MAINE TURNPIKE AUTHORITY

ADDENDUM NO. 1

CONTRACT 2023.02

EXIT 102, NEW ON RAMP  
INTERCHANGE RAMP "A"  
MILE 102.0

VHB: 55327.00 SHEET NUMBER: 2  
 CONTRACT: 2023.02 2 OF 92

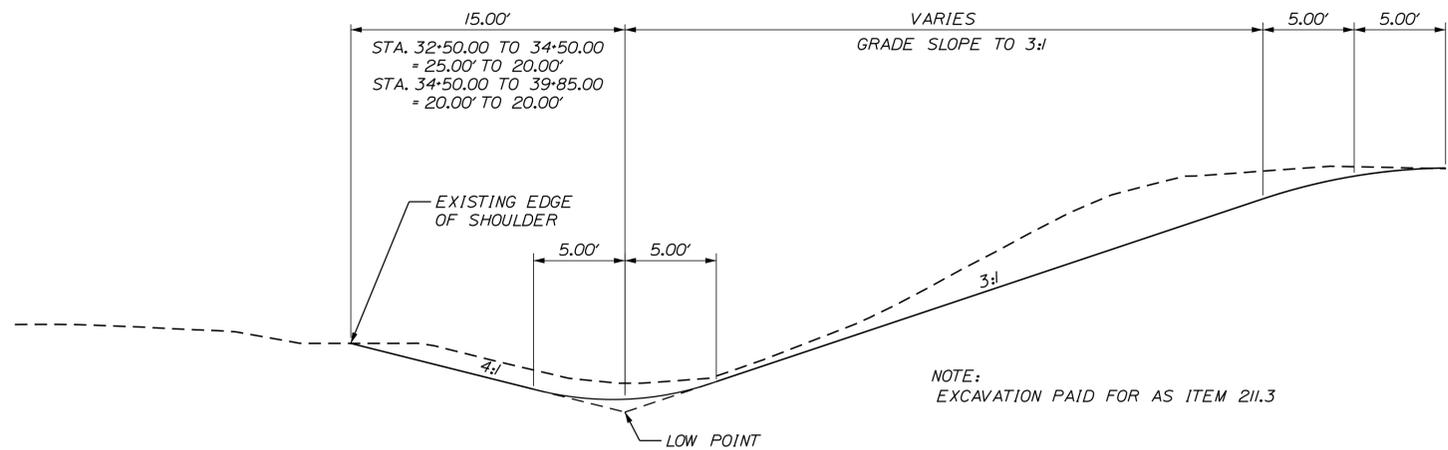
Question 4: Is the milling of the Northbound off-ramp included in the quantity for Item 202.202? It is not listed in the quantity on Sheet 3 Construction notes/Earthwork summary.

Response: *Yes, the milling of the Northbound off-ramp included in the quantity for Item 202.202 – Remove Pavement Surface. Please see revised sheets attached.*

SHEET NUMBER: 8  
 8 OF 92

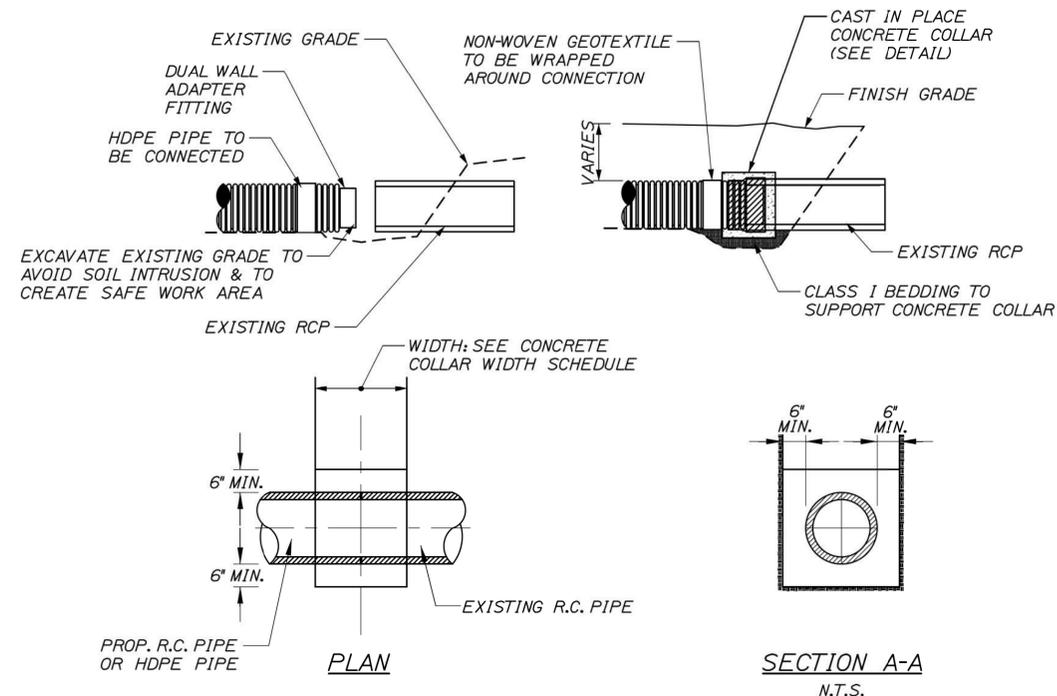
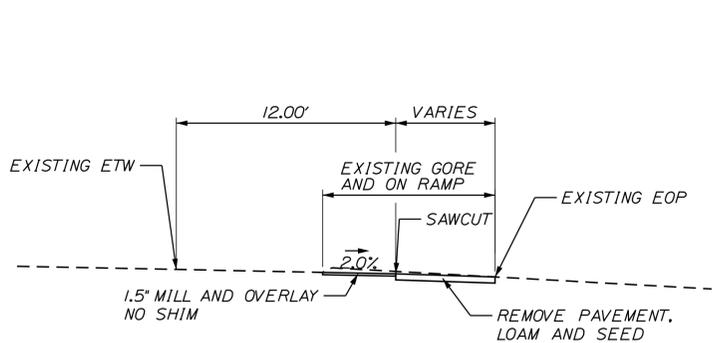
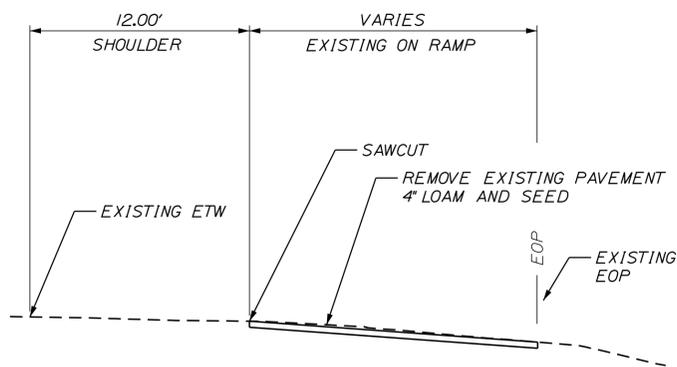
Question 1: Where are concrete collars required?

Response: *A concrete collar is required at the pipe extension at 5209+39, 61.68' RT where a 12" x 8' OPT III pipe will be used to extend and existing RCP pipe under mainline.*
